**REPORT OF THE MONITORING TEAM OF THE INSTITUTE FOR
ENERGY AND ENVIRONMENTAL RESEARCH**

**INDEPENDENT AUDIT OF LOS ALAMOS NATIONAL LABORATORY
FOR COMPLIANCE WITH THE CLEAN AIR ACT, 40 CFR 61,
SUBPART H IN 2001**

Arjun Makhijani, Ph.D.
Bernd Franke

December 18, 2002

Figure 1 November 2001 gamma dose rate at the NEWNET East Gate (new) station
Note: the 41 µR/hr value on 11/28 was considered to be erroneous

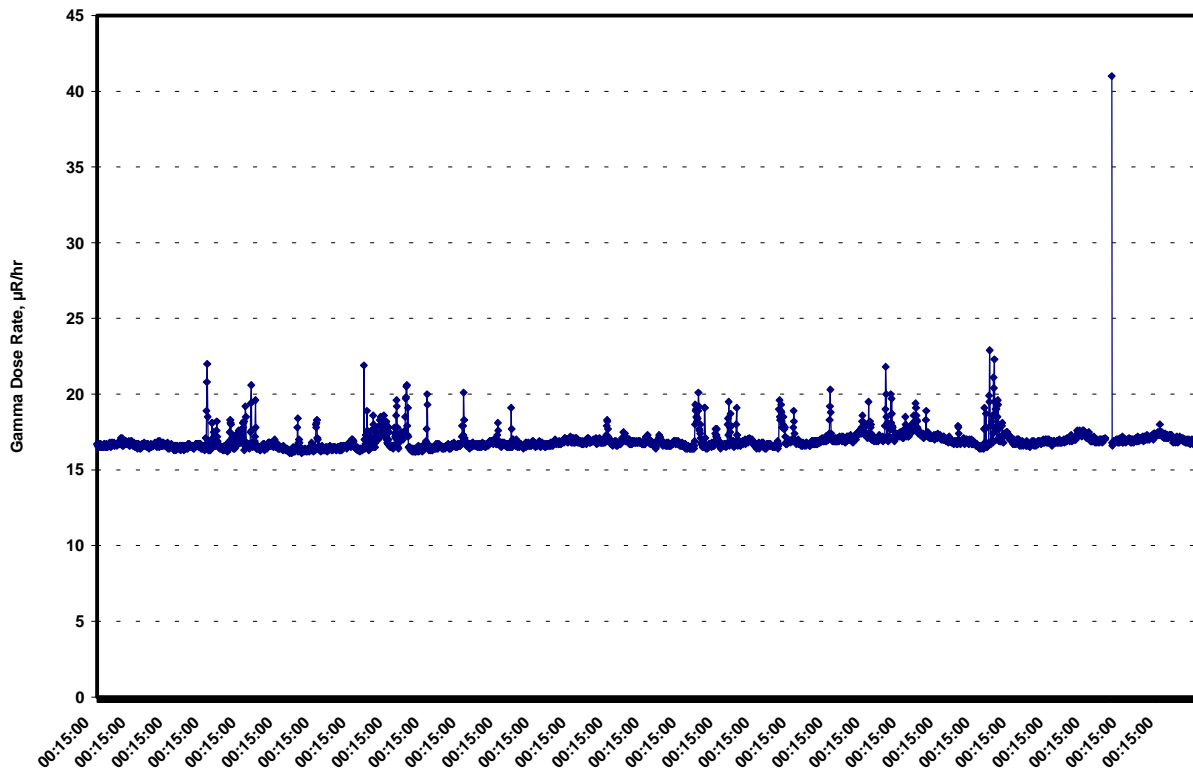
I present a somewhat different approach for the month of November 2001. Upon inspection of the gamma dose rate over time (Figure 1), a gradual shift is evident which may likely be due to instrument calibration.

I suggest that ITAT continues the review of NEWNET data quality and the methodology to use NEWNET data to validate the results of CAP88 calculations.

Figure 4 December 2001 gamma dose rate at the NEWNET East Gate (new) station as a function of wind direction in degrees

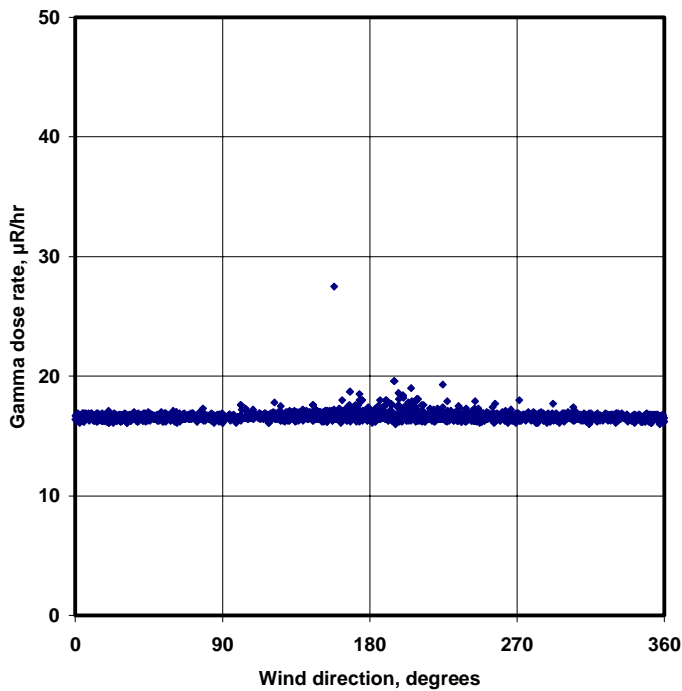
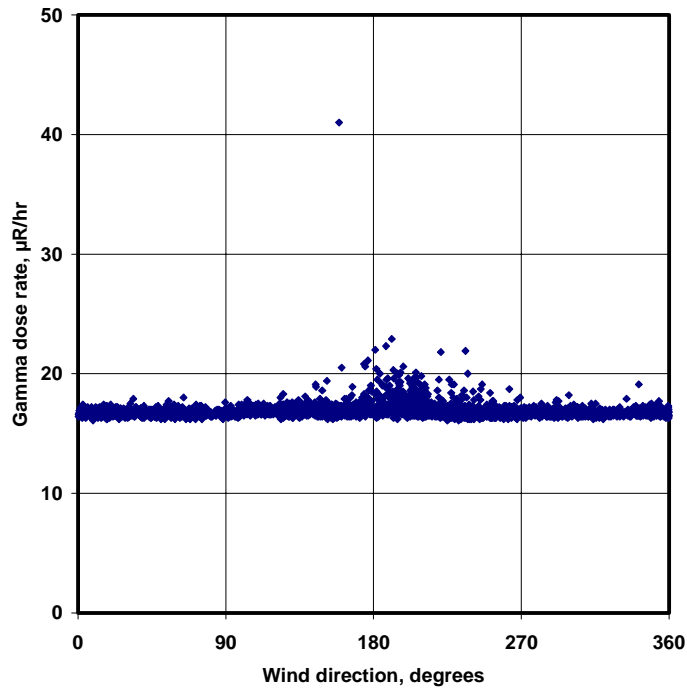
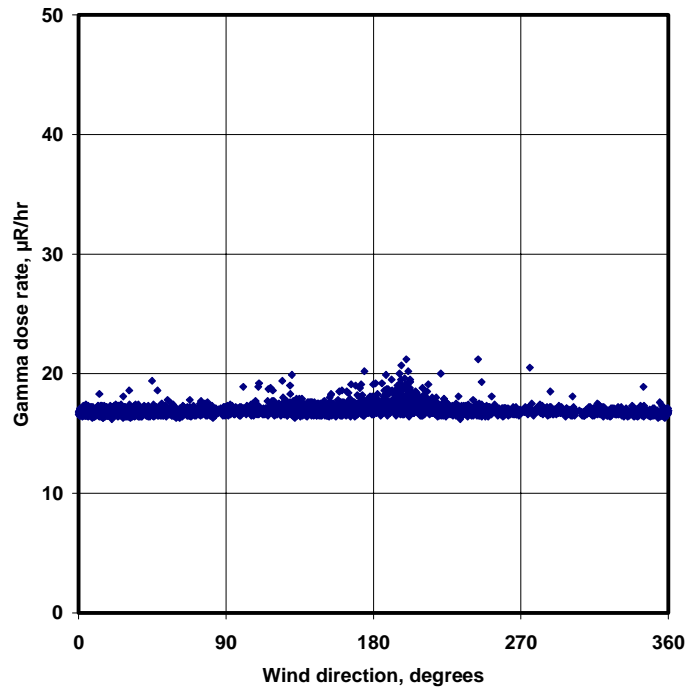
In addition, I would like to direct attention to the gamma dose rates as a function of the wind direction in the month December 2001 (Figure 4) compared to the data for October 2001 (Figure 2) and November 2001 (Figure 3). The increases in gamma dose rates at wind directions <90 and >270 degrees in the month of December 2001 are difficult to explain and may indicate electronic

noise at this station. That comes as a surprise because the station East Gate (new) was equipped with new data loggers that are supposed to have rectified the noise issue.

Figure 1 Wind speed as a function of wind direction at East Gate NEWNET station, August 2002

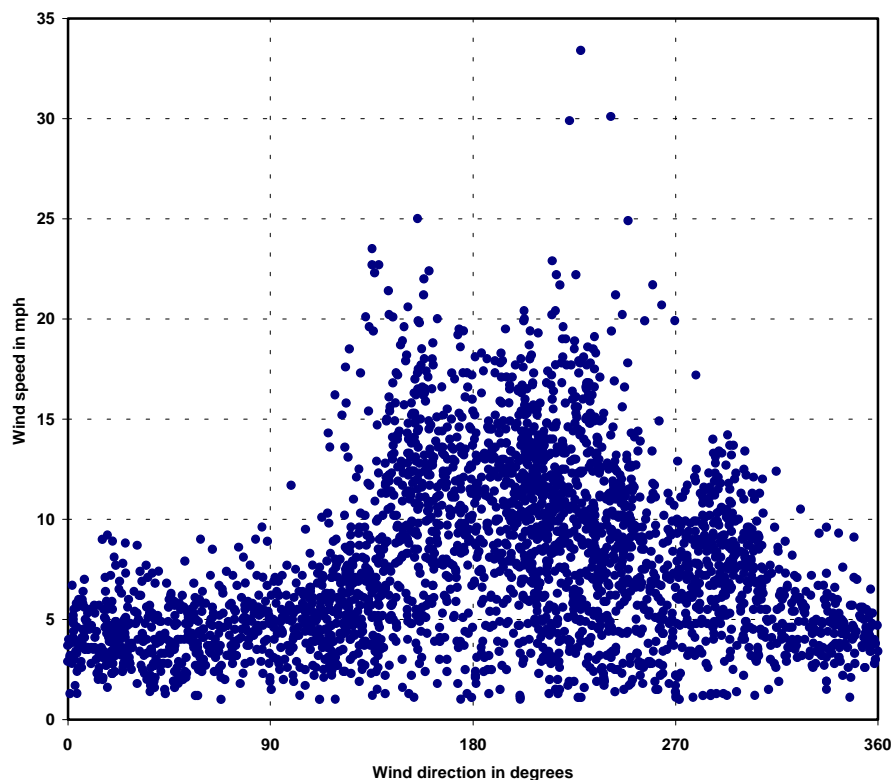
The underlying calculation assumes a steady-state release and is modelled with a simplified flat-terrain model. Both assumptions are not valid in this case. The use of a complex terrain model may lead to a different conclusion for a "TA-21 East" source. In addition, the releases from a diffuse source are most likely to occur during high wind speeds (>10 mph) when material can be readily suspended into air. High wind speed situations are more likely during wind blowing from the South/Southeast (see Figure 1).

With regard to diffuse sources at TA-21-East, the wind speed/direction pattern suggests that the greatest impact to residents from such a source is likely at the North Mesa residences.
